South Texas Project Electric Generating Station 4000 Avenue F - Suite A Bay City, Texas 77414

August 12, 2008
ABR-AE-08000061

South Texas Project
Units 3 and 4
Docket Nos. 52-012 and 52-013
Response to Requests for Additional Information

Attached are responses to NRC staff questions included in Request for Additional Information (RAI) letter numbers 31, 34, 39, 40, 49, 50 and 52 related to Combined License Application (COLA) Part 2, Tier 2 Sections 2.4S and 2.5S. This submittal includes responses to the following Question numbers:

No COLA revision is required as a result of this RAI response.

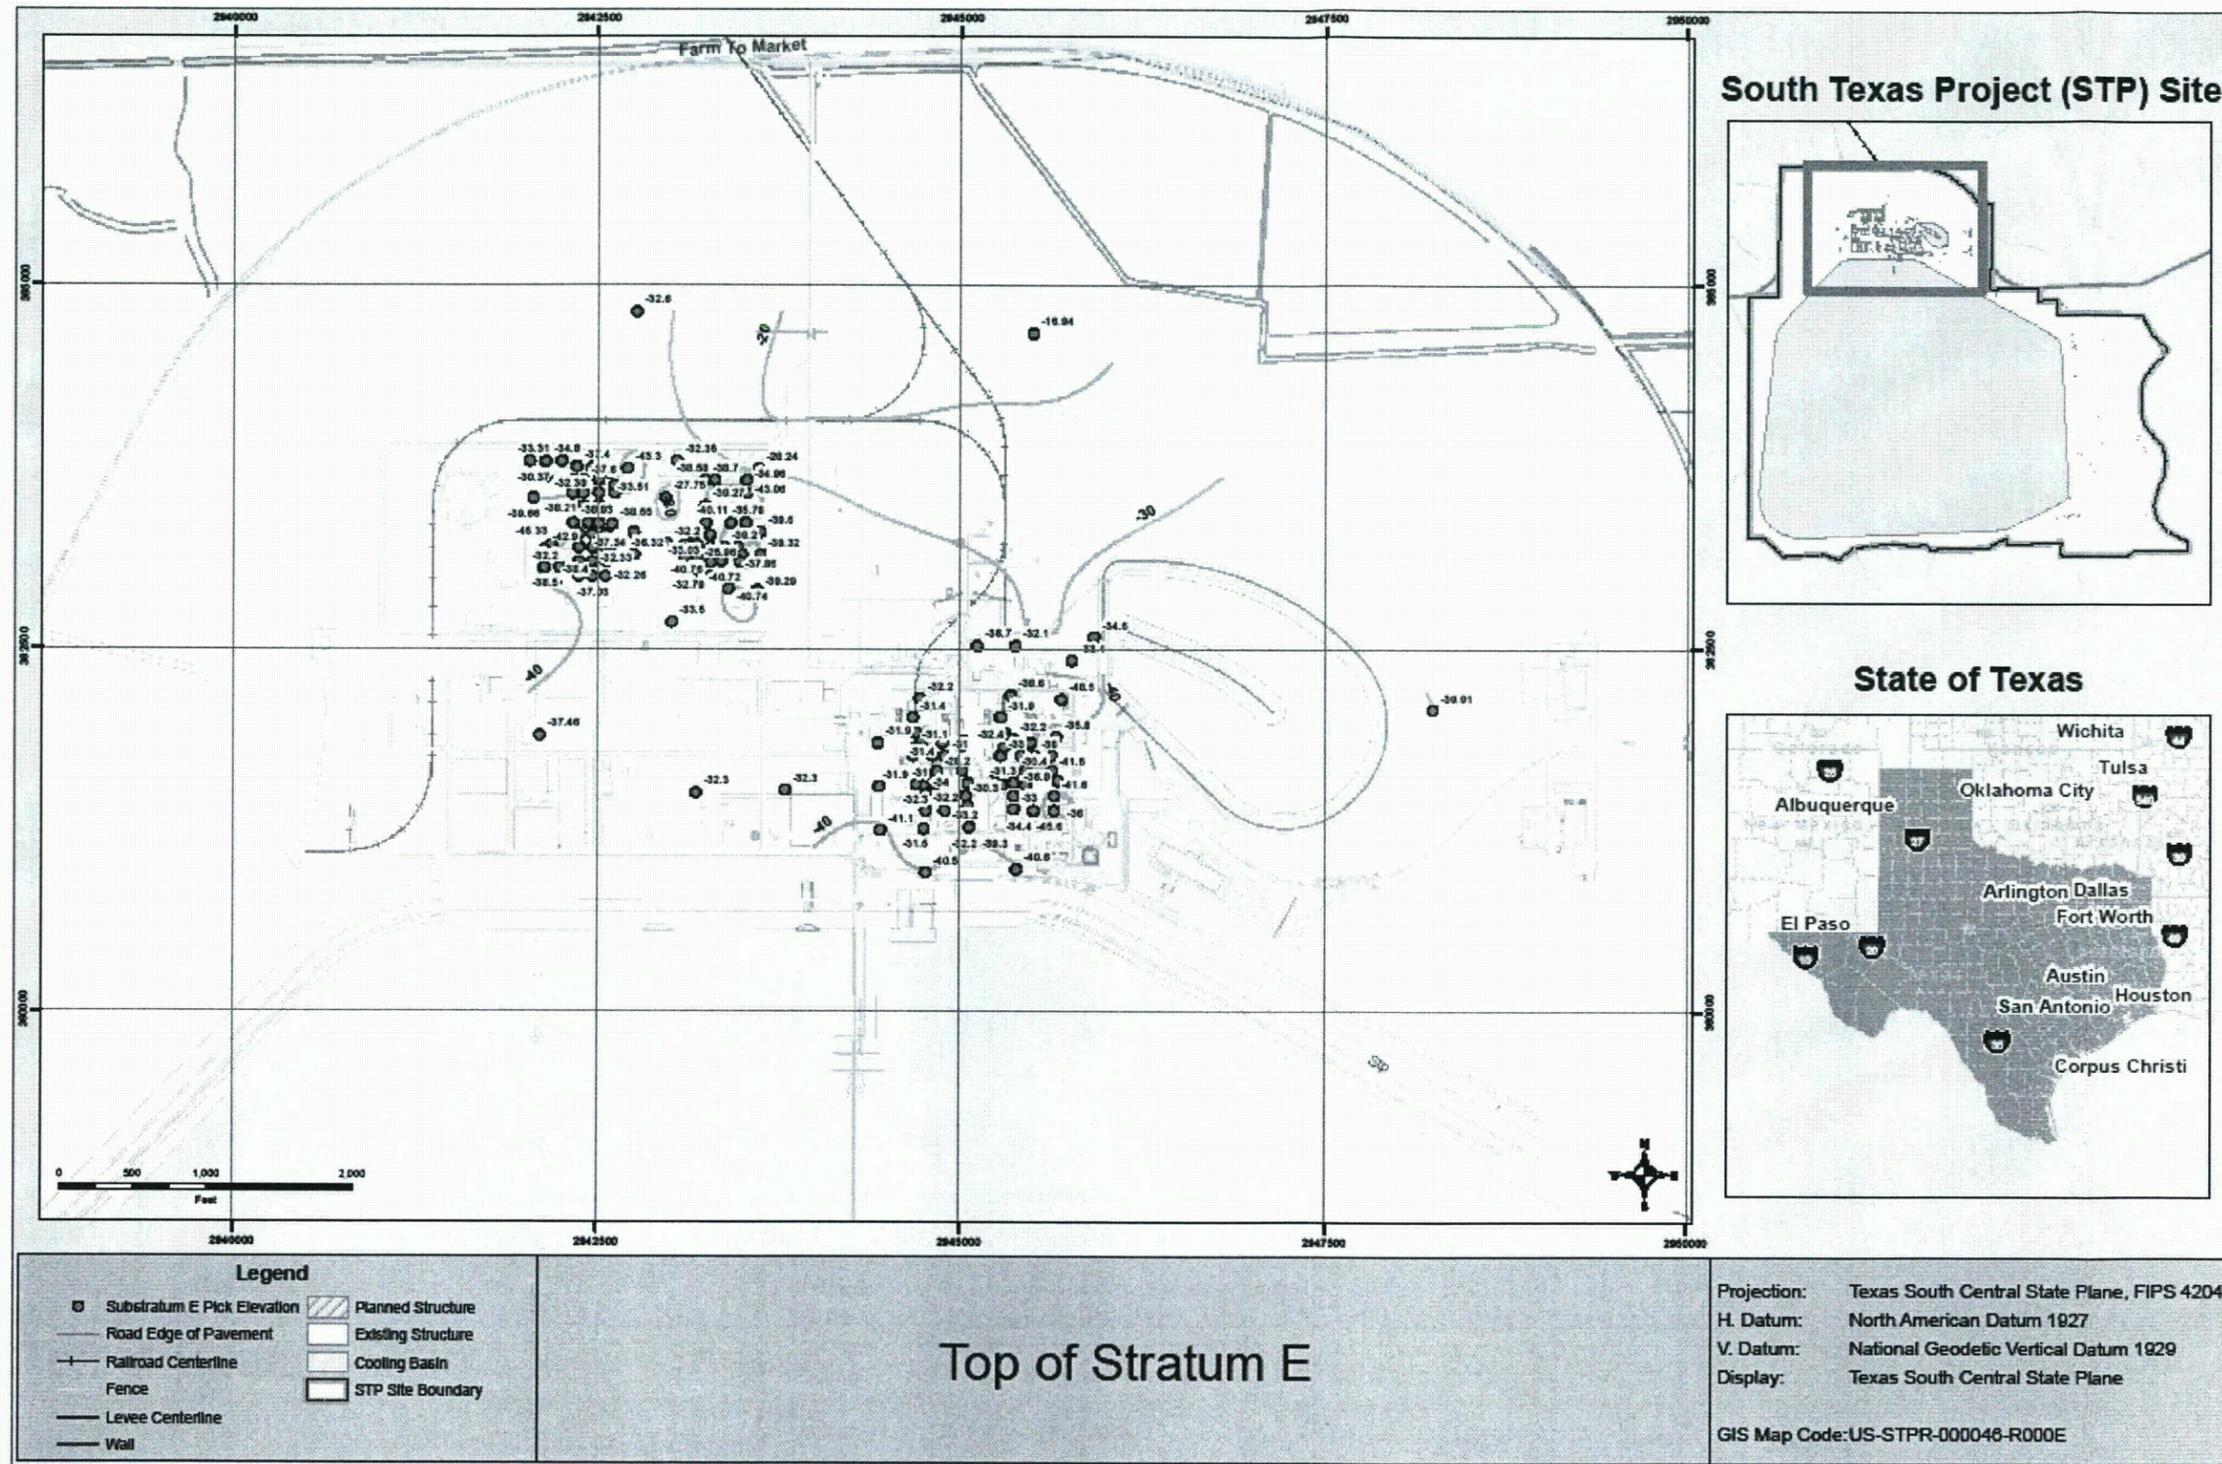
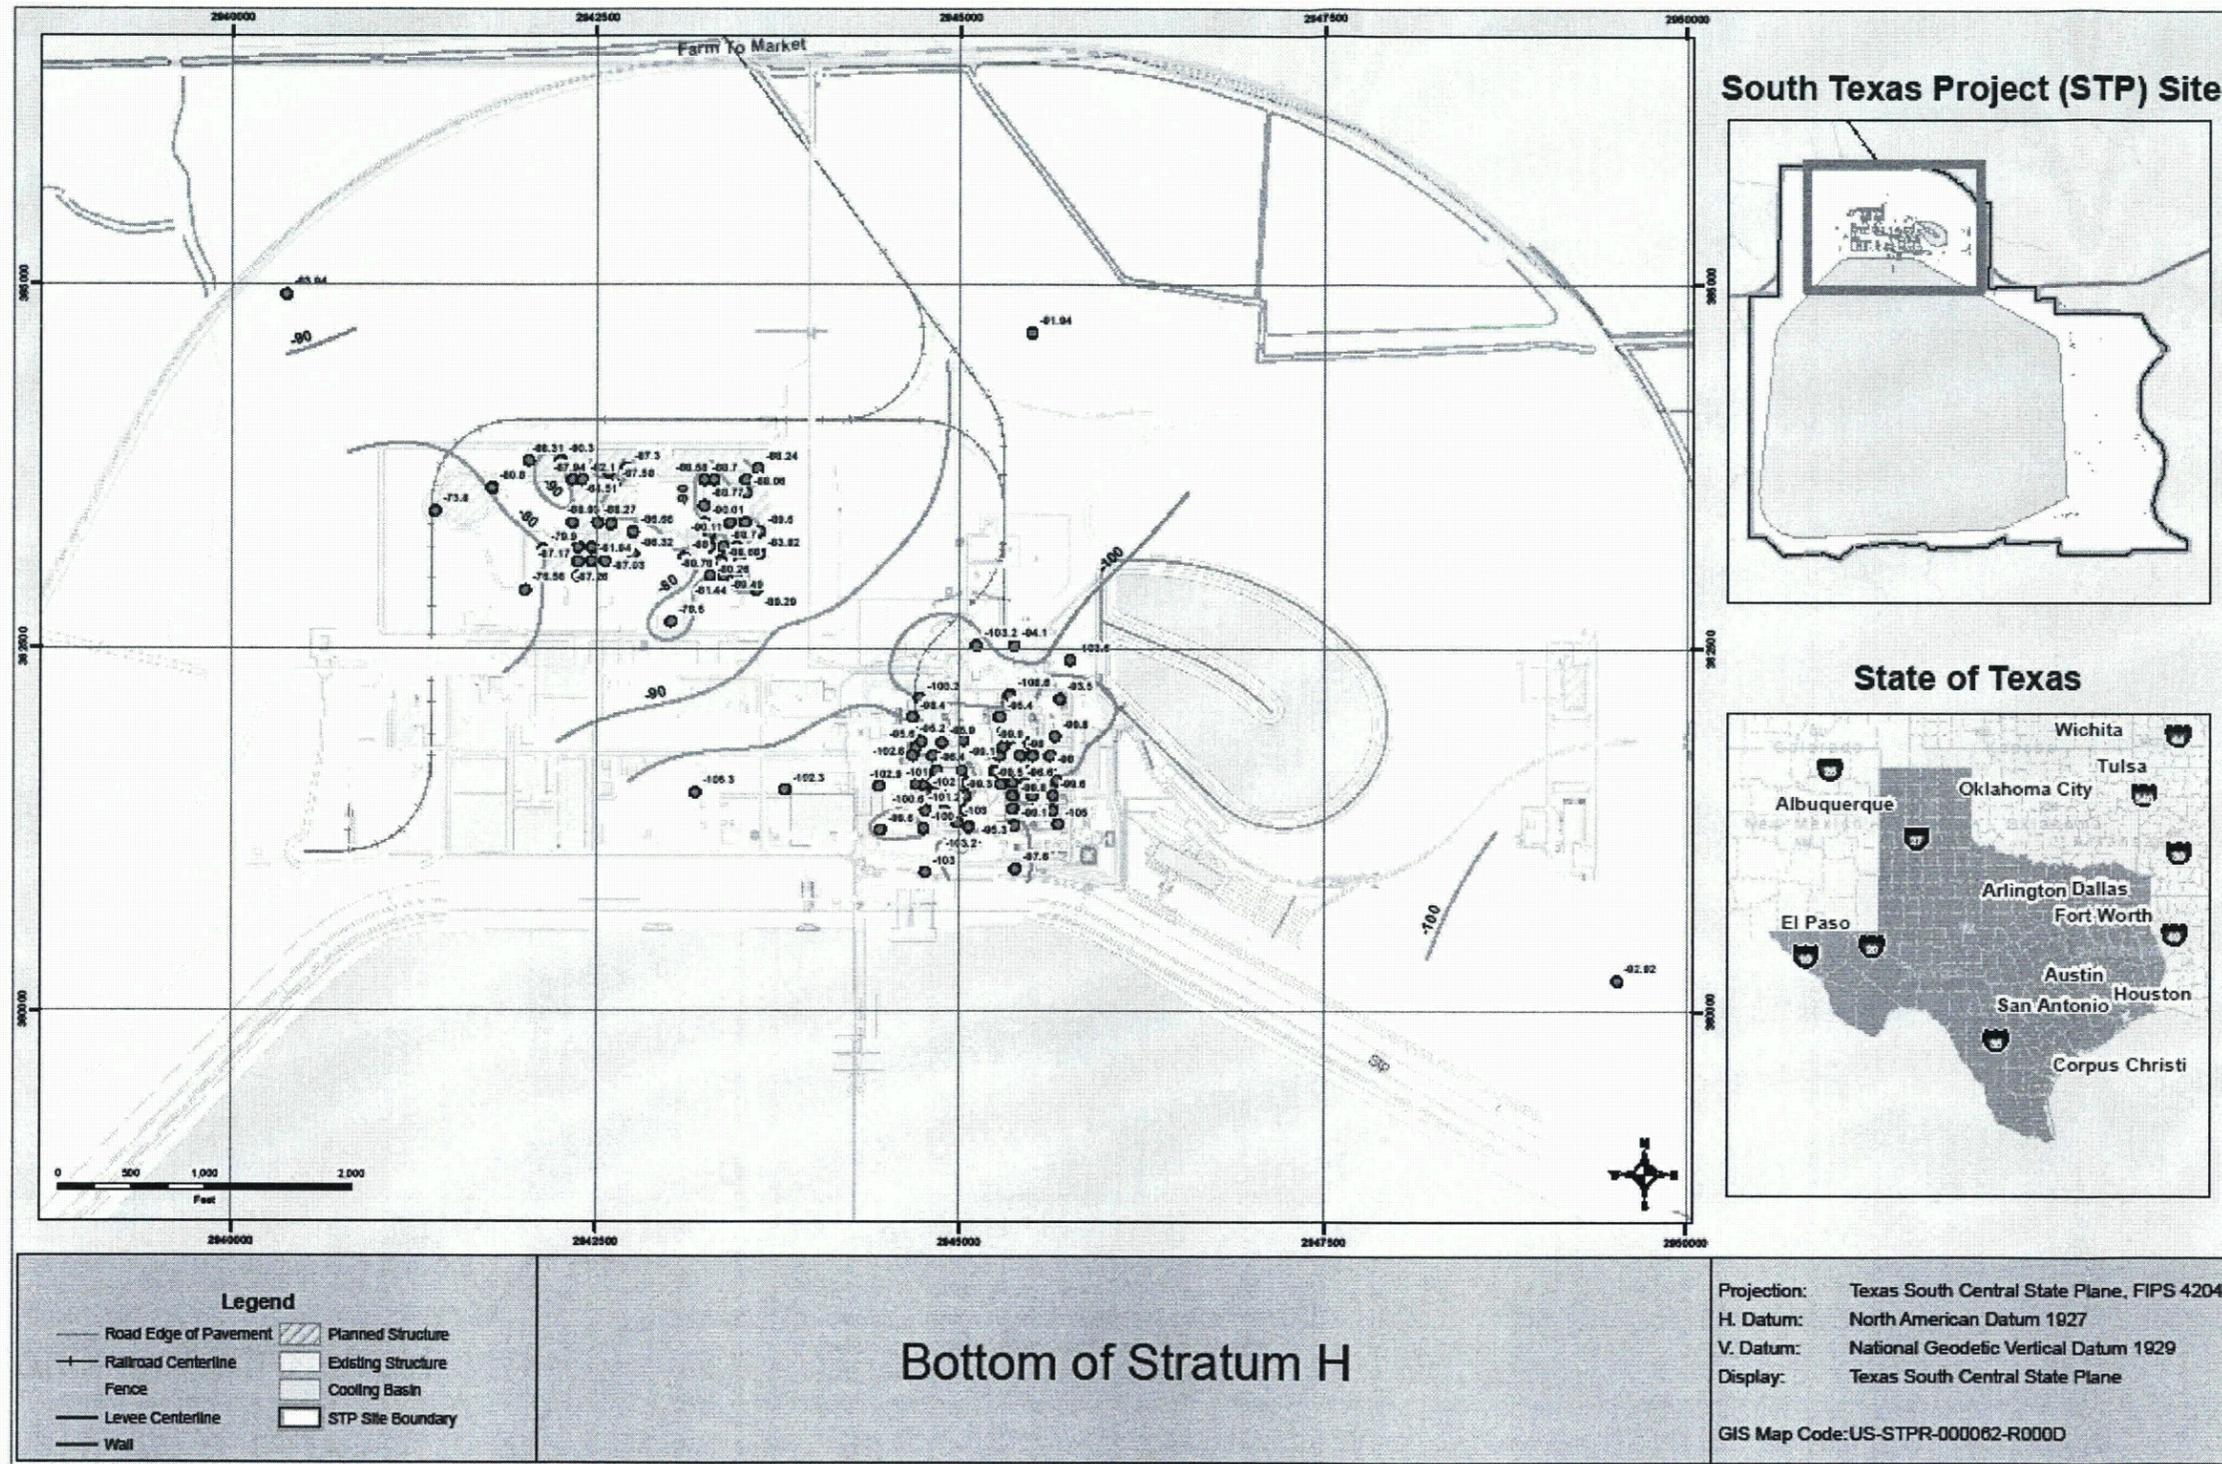
Provide detailed surface maps for top and bottom elevations of both Upper and Lower Shallow Aquifers as they are needed to better understand and predict on-site groundwater flow and pathways. Figure 2.4S.12-10 shows many piezometric wells around Units 1 and 2, but it is not clear whether the water level data from all the wells were used for the water level contour maps in Figure 2.4S.12-19. Please clarify.

The requested maps are attached. The maps are a geostatistical interpretation of available data representing the top and bottom elevations of the Upper Shallow Aquifer (Geotechnical Stratum C from FSAR 2.5S.4) and Lower Shallow Aquifer (Geotechnical Strata E and H from FSAR 2.5S.4). The tension-spline method in ESRI ArcGIS software was used to contour the available data. The data are from the Units 1 & 2 UFSAR (reference) and the STP Units 3 & 4 geotechnical evaluation.

The Lower Shallow Aquifer includes two sand units (Geotechnical Strata E and H) separated in places by a discontinuous clay unit (Geotechnical Stratum F from FSAR 2.5S.4). Where encountered in borings, this clay unit has been observed with a thickness that can range from about 0.7 feet to about 61.5 feet with an average of about 20 feet. However, the encountered thickness at most borings is between about 10 to 30 feet. (It should be noted several borings did not fully penetrate the unit.)

The water level contour maps in Figure 2.4S.12-19 used the data from the observation wells drilled during the 2006 - 2007 subsurface investigation for Units 3 & 4 (the "Units 3 & 4 wells"), because this was the only relevant data available for the two dates represented in that figure. The other piezometers shown in Figure 2.4S.12-10 were installed more than 20 years ago. Most of these piezometers no longer exist or relevant construction details are no longer available. The most recent data available from these piezometers are from May 1, 2006. The earliest data available for the "Units 3 & 4 wells" are from December 28, 2006 (Table 2.4S.12-7). These two data sets are not contemporaneous and, as a result, cannot be combined to prepare contour maps such as those in Figure 2.4S.12-19. Plans are underway to install additional observation wells at the STP site to obtain hydrogeologic information in the vicinity of Kelly Lake and to reduce the uncertainty associated with the groundwater flow paths near the MCR and site boundary.

Figure 2.4S.12 - XX
Potentiometric Surface in the Upper Shallow Aquifer 1, 2, 3

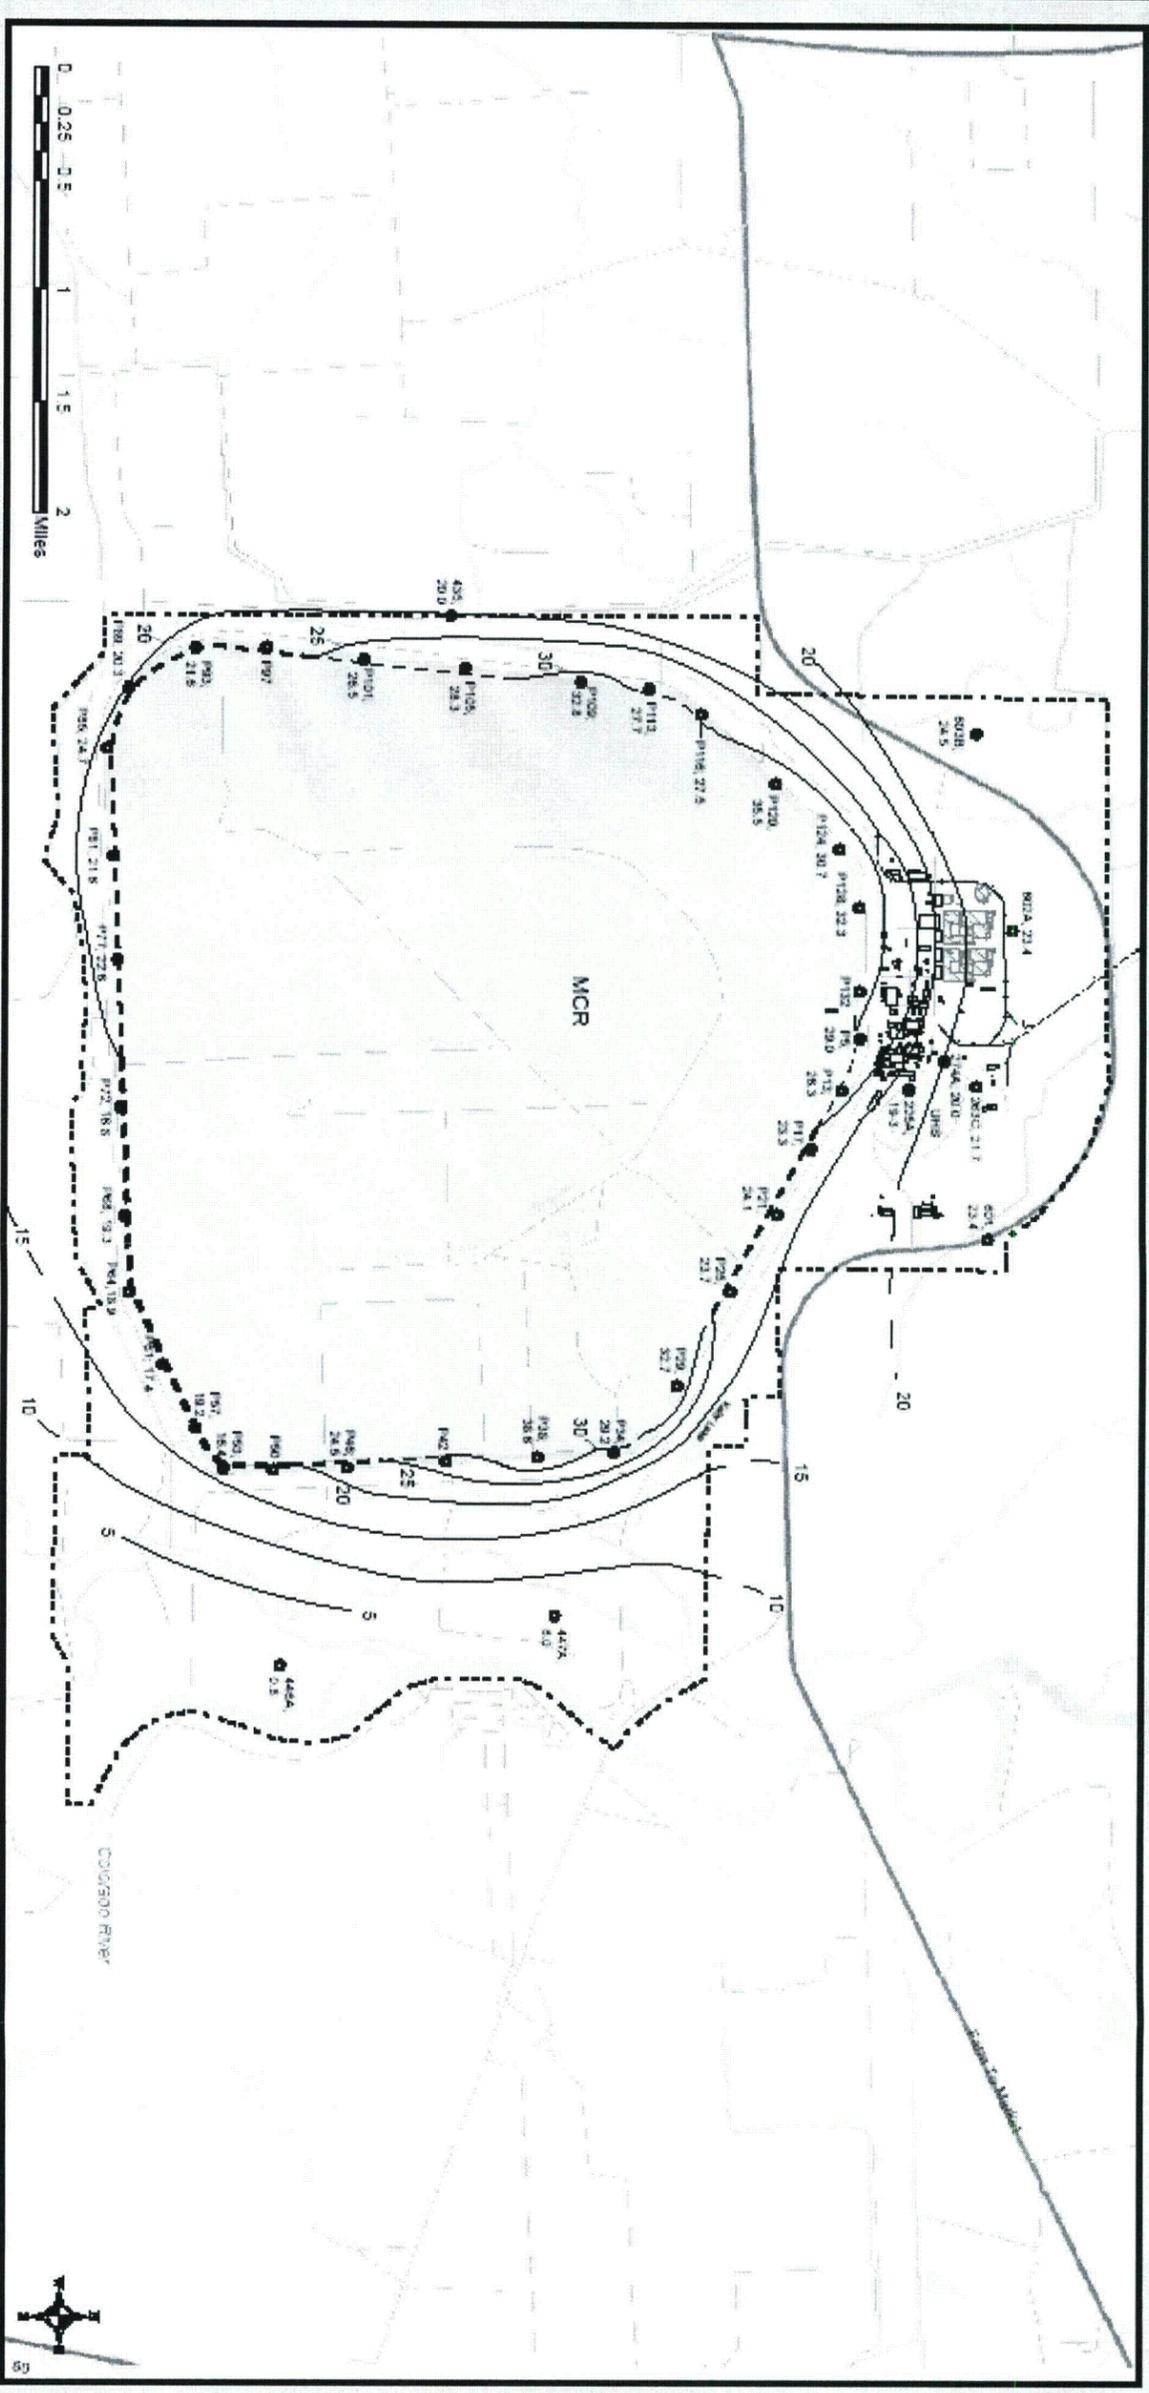
In FSAR Section 2.4S.13.1.2, Conceptual Model, the applicant closes with a four-point summary of the alternate pathways. This needs elaboration, for example, (a) Under item (1), were thermal phenomena and buoyancy of heated water considered when making the statement "... there is no mechanism to lift the liquid ..."? While data are not included, the waste waters may be at elevated temperature relative to the ambient groundwater setting, and buoyancy may be a factor to be considered. (b) Under item (2), it is not clear that the schematic diagram in FSAR Figure 2.4S.12-21 represents actual data. In which tables do the data appear? Please provide a realistic three dimensional analysis. Complete the potentiometric surfaces of the Upper Shallow Aquifer, i.e., show contours underlying the MCR. The potentiometric surfaces of the Lower Shallow Aquifer indicate groundwater flow toward and under the MCR rather than around it. Why would the Upper Shallow Aquifer not also present an under rather than around pathway? Explain the reasons why the pathways presented are the most plausible, by providing the basis for them. (c) Under item (4), the issue of under versus around appears again. In addition, was the concept of the paleochannel raised in FSAR Section 2.4S.12.2.4.1 incorporated into the rationale when discarding this pathway?

Figure 2.4S.12-XX (attached) is a contour map of water-level elevations listed in Table 2.4S.12-XX in piezometers in the Upper Shallow Aquifer at the "A" position in each set around the MCR embankment, and in other available piezometers throughout the site. This map shows the piezometric surface in the Upper Shallow Aquifer beneath and in the vicinity of the MCR, and indicates that groundwater flow is outward from the MCR along the entire length of the embankment.

Figure 2.4S.12-XX is a contour map of water-level elevations in piezometers in the Upper Shallow Aquifer at the "A" position in each set around the MCR embankment, and in other available piezometers throughout the site. This map shows the piezometric surface in the Upper Shallow Aquifer beneath and in the vicinity of the MCR, and indicates that groundwater flow is outward from the MCR along the entire length of the embankment.
